Access Compliance Report

Public Rights-of-Way

(Curb Ramps)

Intersection ID: 19296	Main Street: MEADOWOOD_LN	Cross Street: PROVIDENCE_RD	Location: NE
ADA ID: B6B8E1EABBB7	Ramp Type: BlendTrans2	Initial Pass/Fail: Fail	Overall Compliance: No
Severity Score: 10			
Codes/Mitigation Info/Possible Solution		Field Measurements/Component Compliance

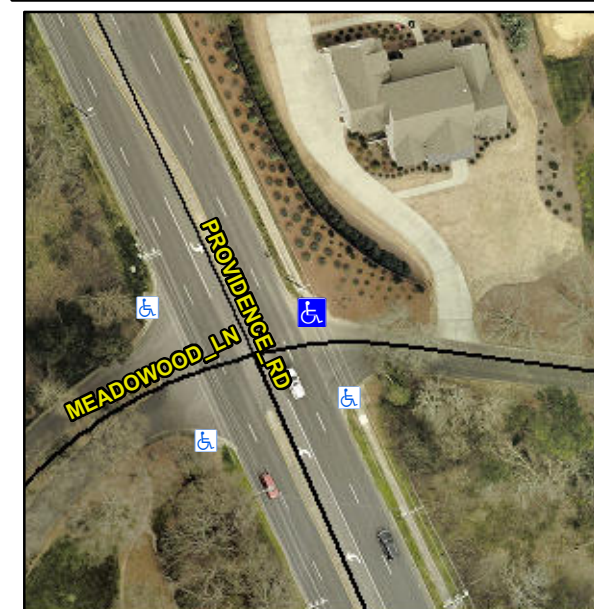
R304.5.1, R304.5.3

Compliance	Description	Data	Compliance	Description	Data
N/A	Ramp Length (in)	96.0	Yes	BlendTrans Slope (%)	3.6
No	Ramp Width (in)	40.0	No	BlendTrans XSlope (%)	4.2
N/A	Flare Type LT	N/A	N/A	Flare Type RT	N/A
N/A	Flare Slope LT (%)	N/A	N/A	Flare Slope RT (%)	N/A
N/A	Flare Traversable LT?	N/A	N/A	Flare Traversable RT?	N/A
N/A	Landing Length (in)	N/A	N/A	DWS Provided?	N/A
N/A	Landing Width (in)	N/A	N/A	DWS Contrast?	N/A
N/A	Landing Slope (%)	N/A	N/A	DWS Length (in)	N/A
N/A	Landing X Slope (%)	N/A	N/A	DWS Full Width?	N/A
N/A	Landing Curb? (Y/N)	N/A	N/A	DWS Offset (in)	N/A
N/A	Shared Landing?	N/A			
N/A	Gutter Ponding?	N/A	N/A	Gutter Slope (%)	N/A
N/A	Gutter Lip Ht (in)	N/A	N/A	Gutter X Slope (%)	N/A
N/A	Painted X Walk1?	No	N/A	Painted X Walk2?	No
	X Walk 1 Direction	To W		X Walk 2 Direction	To SE
	X Walk 1 Width (in)	N/A		X Walk 2 Width (in)	N/A
	X Walk 1 Slope (%)	2.3		X Walk 2 Slope (%)	0.3
	X Walk 1 X Slope (%)	0.3		X Walk 2 X Slope (%)	1.1

Remove & Replace Curb Ramp With Two New Directional Ramps or Equivalent.
